COMMUNITY DEVELOPMENT DEPARTMENT REPORT

HEARING DATE: 10/17/2024
TO: Planning & Zoning Commission
FROM: Linda Ritter, Associate Planner
208-884-5533
lritter@meridiandcity.org
APPLICANT: Laren Baily, Conger Group
SUBJECT: H-2024-0022
Skyranch AZ, RZ, PP and MDA

D. Preliminary Plat (date: 5/22/2024)

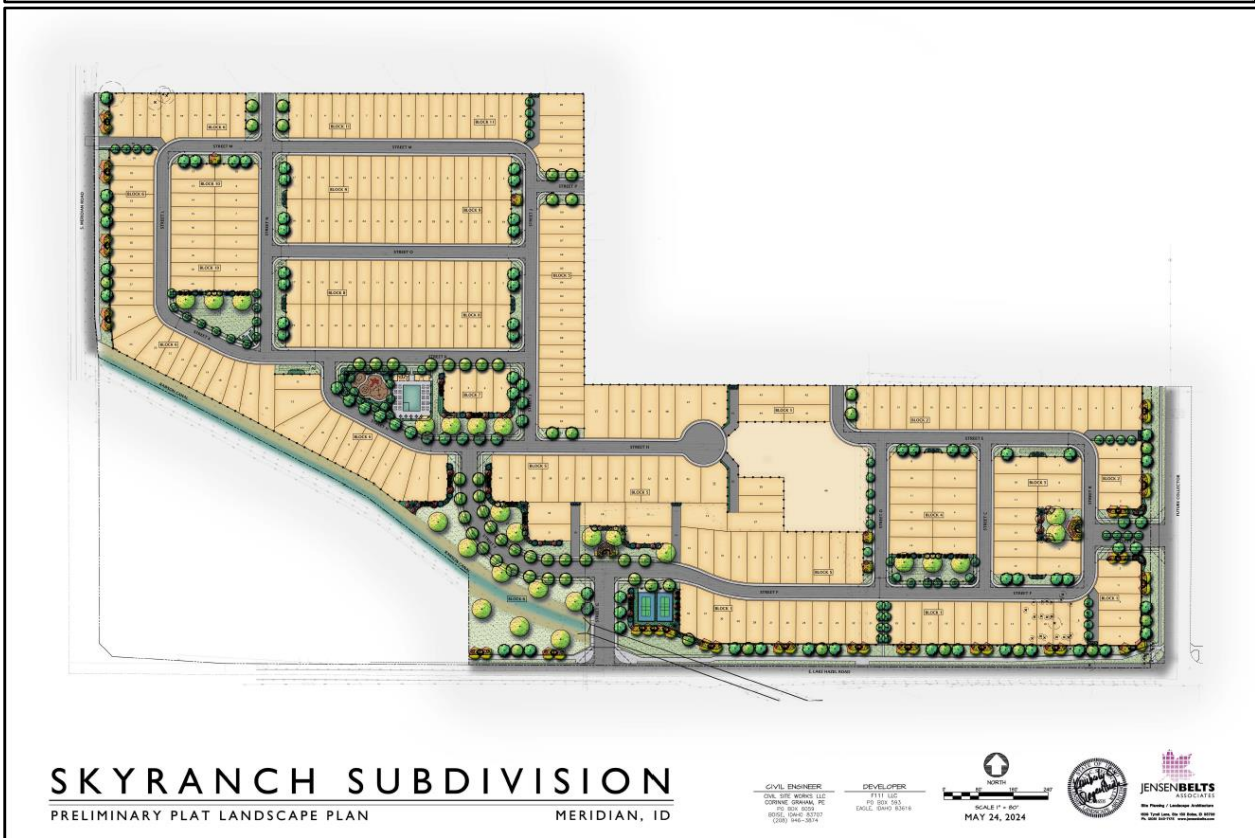
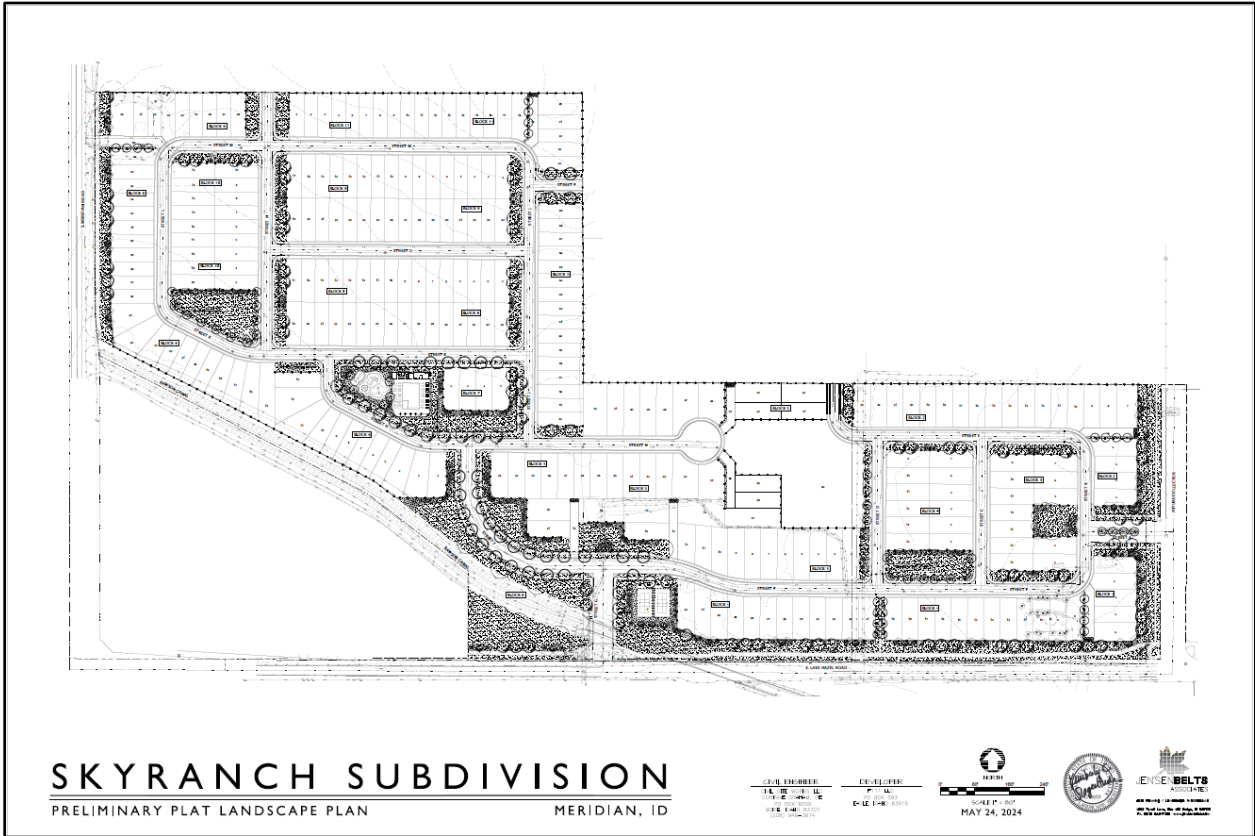
Staff recommends that the applicant provide a mix of dwelling types within the residential area such as single family attached or townhomes within Block 8 (lots 2-17 and lots 19-34) and Block 9 (lots 2-17 and lots 19-34) of the proposed development as allowed by the Comprehensive Plan within the R-15 zoning district.

Per UDC 11-6C-3A.1, through properties are prohibited except where it is shown that unusual topography or other conditions make it impossible to meet this requirement. Through properties shall be limited to one (1) street access on one (1) frontage, designated by a note on the final plat. The applicant needs to revise the plat to remove one of the frontage roads for Lot 40, Block 5.

The applicant is proposing a cul-de-sac that exceeds the maximum five hundred (500) feet in length. The applicant needs to request a waiver from counsel for exceeding the maximum length for dead end streets.

It appears that some of the block lengths exceed the 750 feet. The applicant did not submit a revised block face length exhibit for review as requested.

E. Landscape Plan (date: 5/24/2024)

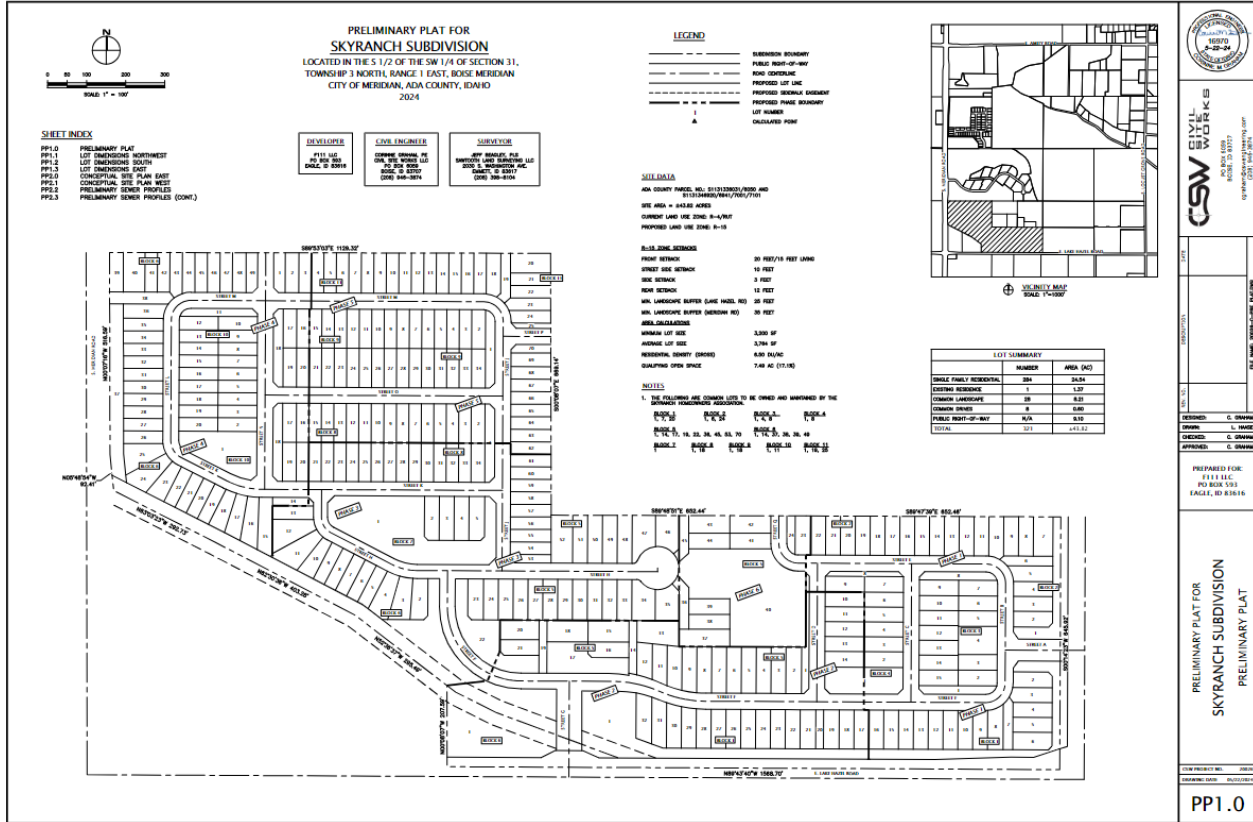
The applicant shall add a mitigation section to the landscape plan for trees meeting the criteria above that are removed.

H. Site Amenities

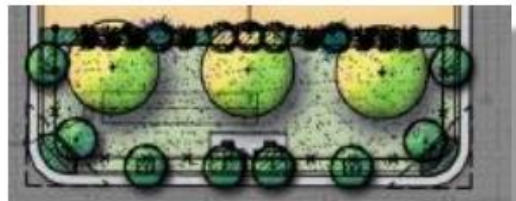
Although the applicant is proposing a berm, landscaping and fencing around the sports court, staff feels the location would be better if relocated to Lot 1 Block 10 or Lot 1 Block 7 away from the primary entrance to the subdivision which is supported by the Comprehensive Plan policies below.
